**Group of Experts for the revision of the IMO/ILO/UNECE
Guidelines for Packing of Cargo Transport Units**

Proposals for amendments to the final draft of the CTU Code:

**Proposed text for Annex 14, Appendix 5 (bedding
arrangements)**

Transmitted by the experts of Germany, Slovakia and Sweden

Figure 14.70 Straddle twin-beam arrangement

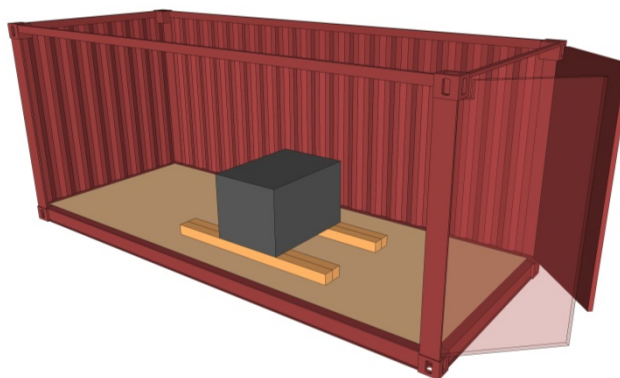
2.6 When four longitudinal support beams instead of two beams are used, these should be arranged as straddled twin-beams.

Figure 14.71 Load distribution for ISO containers tested for concentrated cargo.

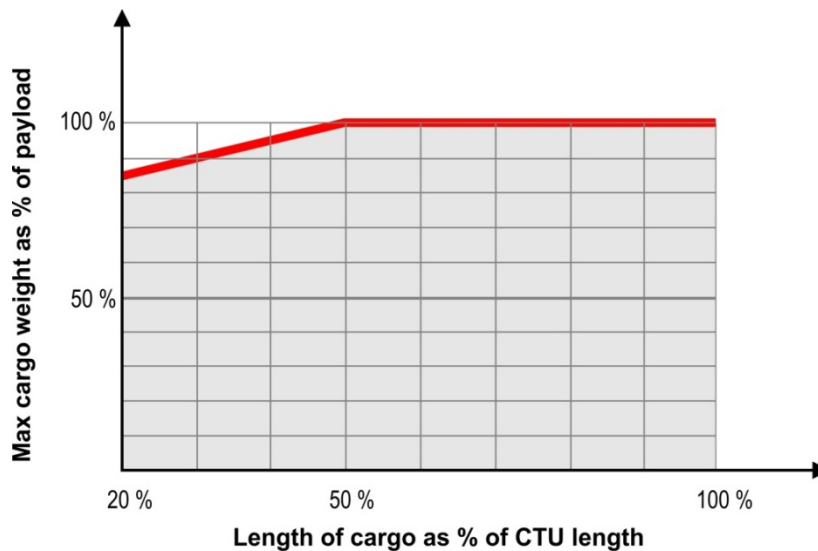
2.10 The minimum length of a cargo which is resting on supports near the side beams of a general purpose ISO container is:

$$r = 2 \cdot L \cdot \left(\frac{m}{P} - 0.75 \right) \text{ [m]} \text{ (Need only be calculated if } m \text{ is greater than 75\% of } P \text{)}$$

In all cases the minimum length of the concentrated cargo should be 20% of the container length *L*.

Figure 14.74 Narrow cargo placed on longitudinal support beams.

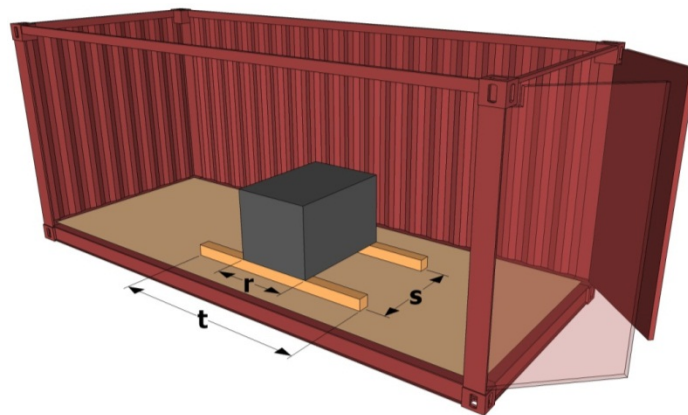
3.2 The minimum length of longitudinal bedding beams t should be taken as the minimum required cargo length according to sections 2.8 through 2.15 above.

Figure 14.76 Narrow cargo placed on transverse support beams.

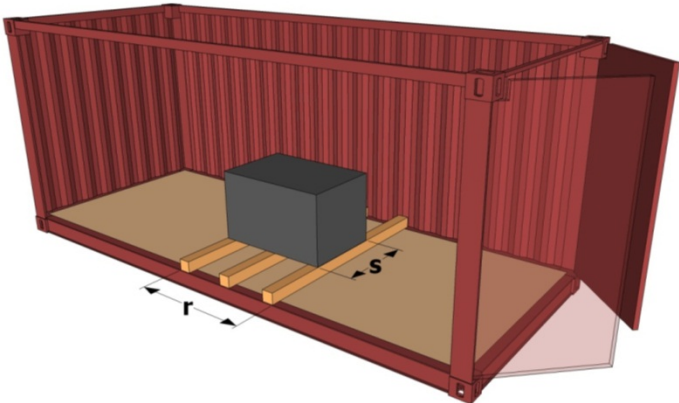
3.6 The required bending strength of transverse bedding beams should be determined by the following formulas:

Rigid cargo: $n \cdot W = \frac{600 \cdot m \cdot (2.8 - s) - 8200 \cdot t_e}{\sigma}$

Flexible cargo: $n \cdot W = \frac{210 \cdot m \cdot (4.6 - s) - 2500 \cdot t_e}{\sigma}$
